MIKE CAUSEY, INSURANCE COMMISSIONER & STATE FIRE MARSHAL
BRIAN TAYLOR, CHIEF STATE FIRE MARSHAL

RE: 2018 NC Building Code Section 1011.5.4 Dimensional uniformity

Re: **Request for Formal Interpretation (N.C. Gen. Stats. § 160D-1127)**
Rowan Cabarrus Community College Outdoor Classroom Phase II (the "Project")
1333 S. Jake Alexander Blvd., Salisbury, NC

RE: 2018 NC Building Code Section 1001.1 General and 1003.1 Applicability

Exhibit A
(to Attachment A – WCCC 8/02/22 Request for Interpretation)
Location Key for Stair Runs that identifies the runs of stairs on project with letters A-W

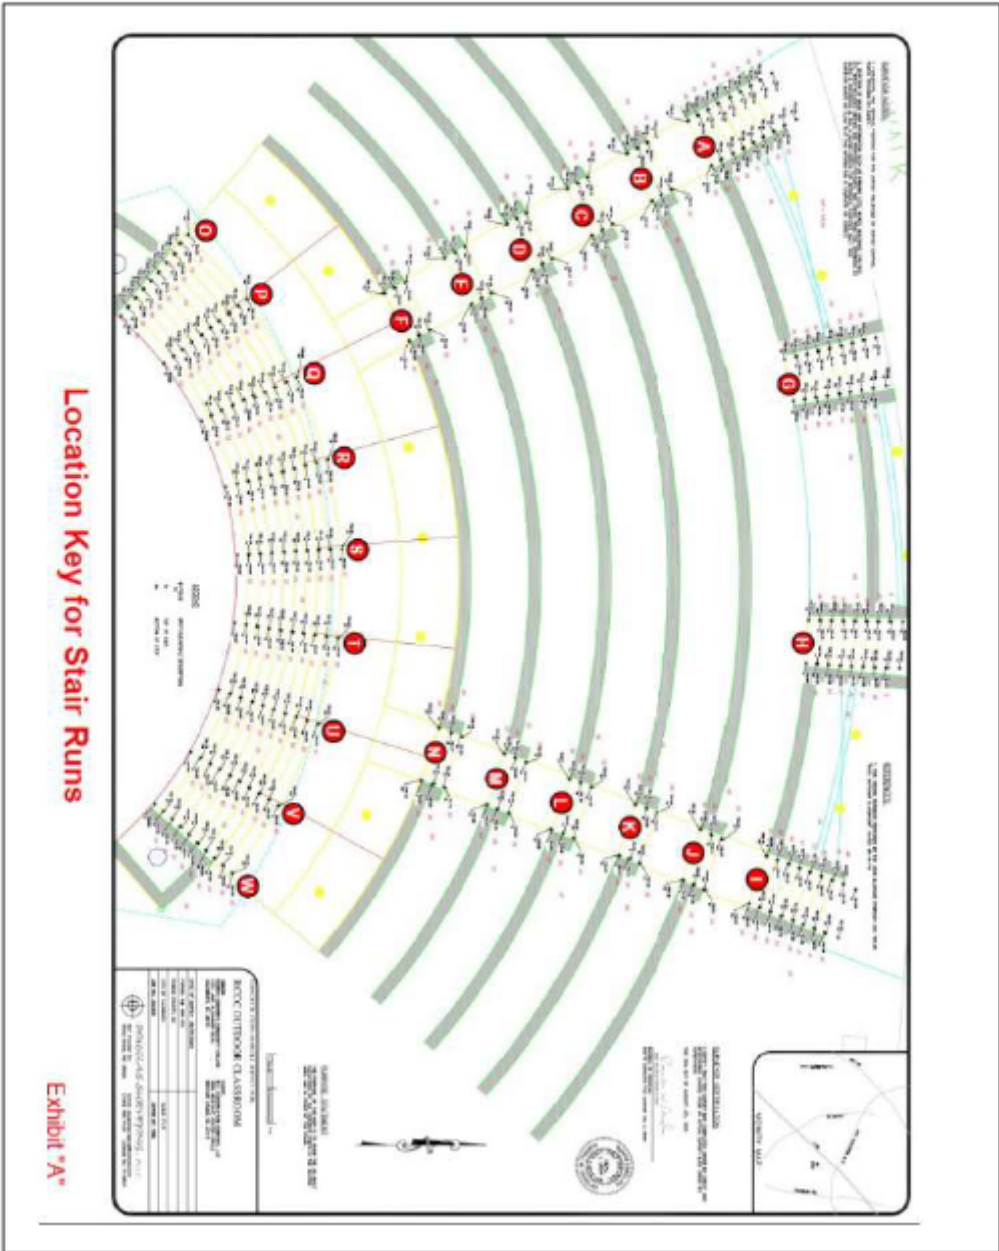
"WCCC submits this request seeking a formal interpretation in connection with certain steps/stairs constructed on the project. For location reference purposes, please see the attached Exhibit "A,"

Request No. 1: Whether the steps in the aisles labeled B through F and J

Request No. 2: Without necessarily agreeing that any steps associated with the stage and labeled O through W are considered egress steps that may not comply with the building code (WCCC expressly reserves the right to argue otherwise), to the extent that such steps are considered egress steps that do not comply with building code, can the steps be brought into compliance with the building code with the use of a barrier?"

Conclusions: *Since a code-compliant means of egress system is provided via each end of the seating rows to a yard at grade level, stairs B thru F and J thru N are considered landscape steps. Landscape steps are not required to comply with the means of egress requirements of the 2018 NC Building Code. A code-compliant means of egress system from the stage is provided at stairs O and W. With the addition of a barrier along the curved portion of the stage at stairs P thru V, egress from the stage is prevented from stairs P thru V. Since these steps are no longer used for egress, they become decorative steps and are not regulated by the 2018 NC Building code.*

Exhibit D
(to Attachment A - RCCC 12/16/21 Request for Interpretation)
Location Key for Stair Runs labeling on the as-built spot elevation survey all the runs of stairs on the project with letters A-W (for reference purposes only)

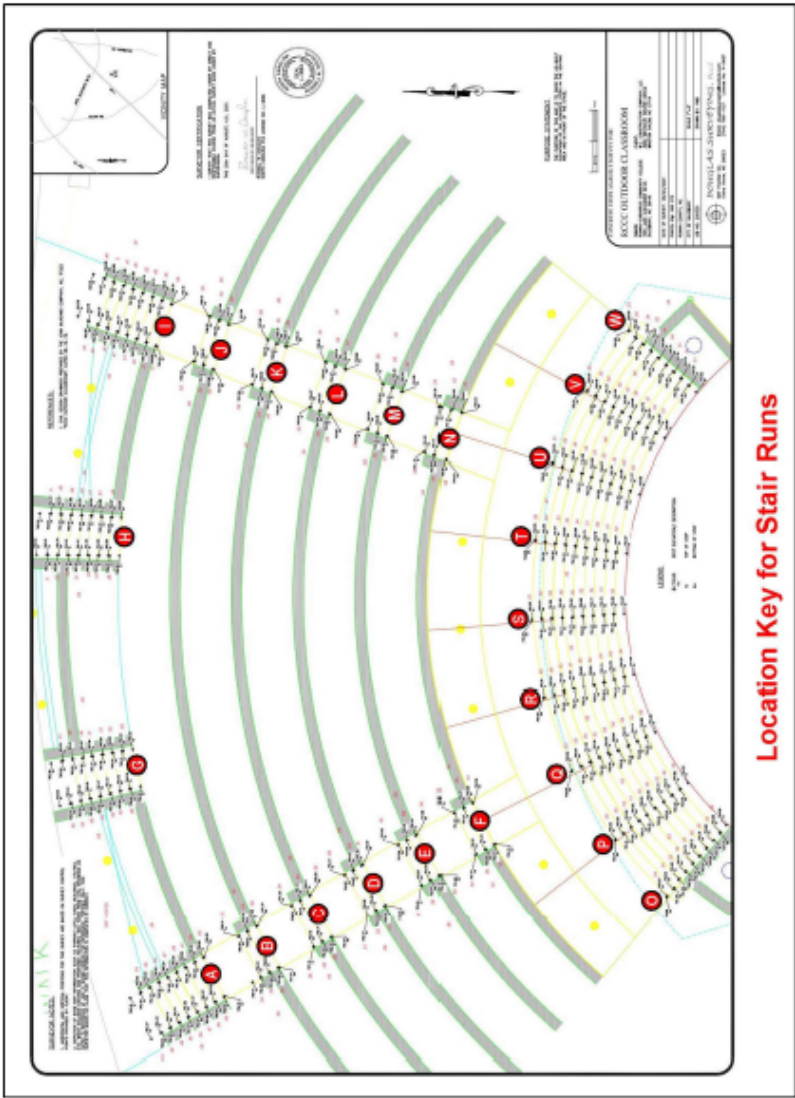
3. Curved Steps at Stage (labeled O through W on Exhibit D)
 - a. Based on as-built survey (Exhibit C), please identify which runs of steps are not in compliance with 2018 NC Building Code.
 - b. For purposes of Code compliance, is it proper to assess all runs labeled O through W on Exhibit D, or just the ends with handrail (labeled O through W on Exhibit D)?”

- 1a. Steps labeled B through F and J through N on Exhibit D appear to be "stepped aisles".
- 1b. Section 1029.13.2.2.1 is the correct reference for addressing allowed riser height tolerance for stepped aisles.

- 1c. Section 1029.13.2.2.1 limits the riser height uniformity tolerance for stepped aisles to 3/16 inch unless an increase to 3/8 inch is required to "maintain adequate sightlines" for adjacent seating served by the stepped aisle. Attachment B below does not demonstrate a need for a 3/8 inch tolerance to maintain adequate sightlines for adjacent seating; therefore, the uniformity tolerance is limited by Section 1029.13.2.2.1 to 3/16 inch for the plan shown in Exhibit C.

- 2a. Steps labeled O through W on Exhibit D appear to be stairways providing egress and convenience for the performance area. Steps labeled A, G, H and I appear to be stairways providing access from an adjacent walkway to the seating area.

- 2b. Section 1011.5.4 is the applicable code section for steps labeled A, G, H, I and O through W on Exhibit D. The allowed maximum tolerance from the smallest to the greatest riser height is 3/8 inch.

- 3a. Any riser difference greater than 0.03125 feet (3/8 inch) of the smallest to the largest riser is not compliant with the applicable code requirement (ref. Section 1011.5.4).

- Steps O are in compliance.
- Steps P are in compliance.
- Steps Q are not compliant because the difference in riser height from 0.50 to 0.56 is 0.06 feet which exceeds the allowed 0.03125 feet.

- Steps R are not compliant because the difference in riser height from 0.49 to 0.54 is 0.05 feet which exceeds the allowed 0.03125 feet.
- Steps S are not compliant because the difference in riser height from 0.51 to 0.57 is 0.06 feet which exceeds the allowed 0.03125 feet.

- Steps T are not compliant because the difference in riser height from 0.49 to 0.56 is 0.07 feet which exceeds the allowed 0.03125 feet.
- Steps U are not compliant because the difference in riser height from 0.50 to 0.54 is 0.04 feet which exceeds the allowed 0.03125 feet.

- Steps V are not compliant because the difference in riser height from 0.49 to 0.53 is 0.04 feet which exceeds the allowed 0.03125 feet.
- Steps W are not compliant because the difference in riser height from 0.50 to 0.54 is 0.04 feet which exceeds the allowed 0.03125 feet.

- Summary:
- Steps O and P comply with Section 1011.5.4.
 - Steps Q thru W do not comply with Section 1011.5.4.
 - Steps S, T and V could be made compliant if the bottom riser is marked as required by Section 1011.5.4.1.

- Steps U could be made compliant if the top riser is marked as required by Section 1011.5.4.1.
- 3b. Because steps O through W are all available to be traversed, Steps O through W must all comply with Section 1011 – Stairways.
